# MODIFICATION RECOMMENDED

## 8757D-01

# S E R V I C E N O T E

## 8757D Scalar Network Analyzer

**Figure 1.** Locate and remove VR3

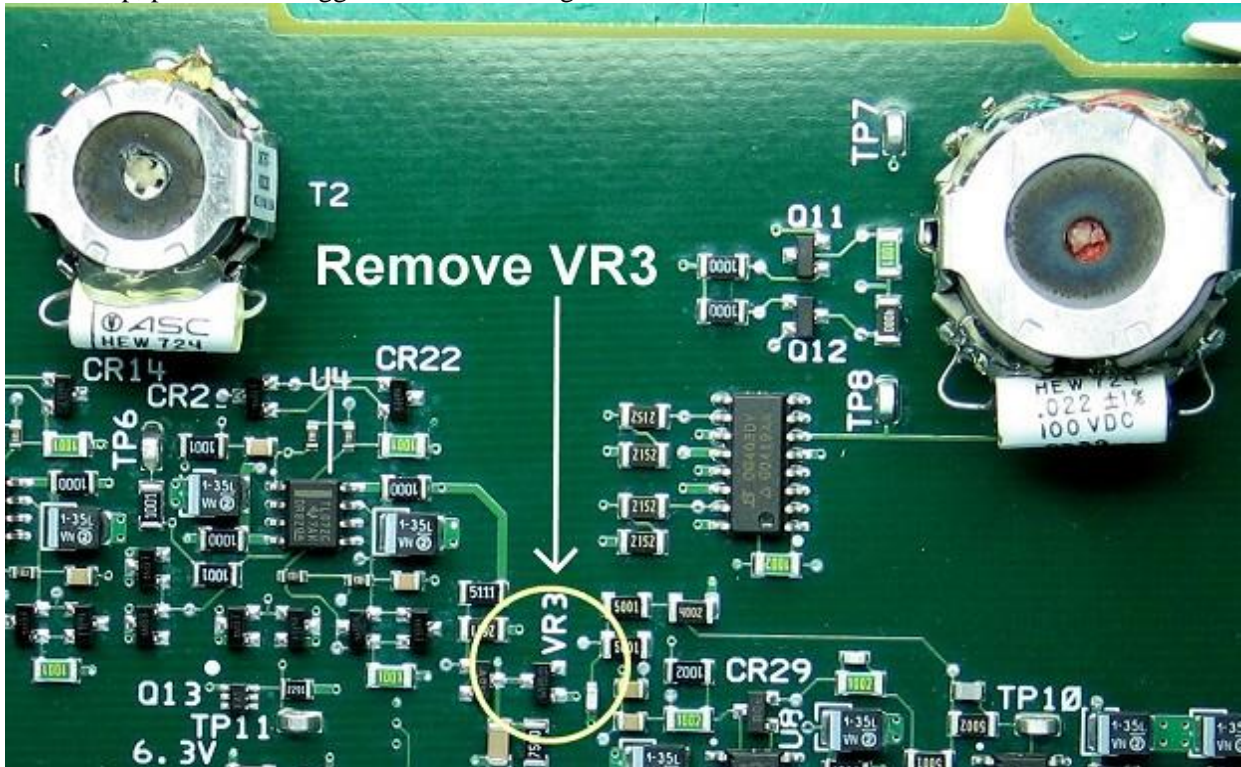
When the 8757D logger board was changed to use surface mount parts (sometime around 2003), a 6.2 V reference Zener diode (VR3) was used that did not meet the required temperature drift specification. This diode may cause the 8757D to fail its dynamic accuracy test as measured with the 11613A/B. Typically it may fail if the temperature drifts by more than 2 degrees from that used on its original calibration. While this may cause the dynamic accuracy test to fail, the customer's end result measurement will most likely not be affected significantly. This is because the added error due to the temperature drift is typically under 0.1 dB while the detector specification is 0.4 dB or more. In addition, other scalar uncertainties, such as mismatch errors, will push the total measurement uncertainty to about +/- 1-2 dB. As a result, the 0.1 dB increase in error is probably negligible

Each logger board (08757-60146) containing surface mount parts should have its reference Zener diode (VR3) replaced. The replacement Zener diode is a through-hole part (1902-3512).

If an unmodified logger board is found, the Zener diode VR3 should be removed (see figure 1.) The new Zener diode should be connected to the same location via two wires. Once properly soldered, it should be glued in place using quick-setting (5 minute) epoxy. Make sure that polarity is observed. See figure 2 for placement. Allow time to cure. Once the instrument has been reassembled and warmed up, perform the logger calibration using the 11613A/B calibrator.
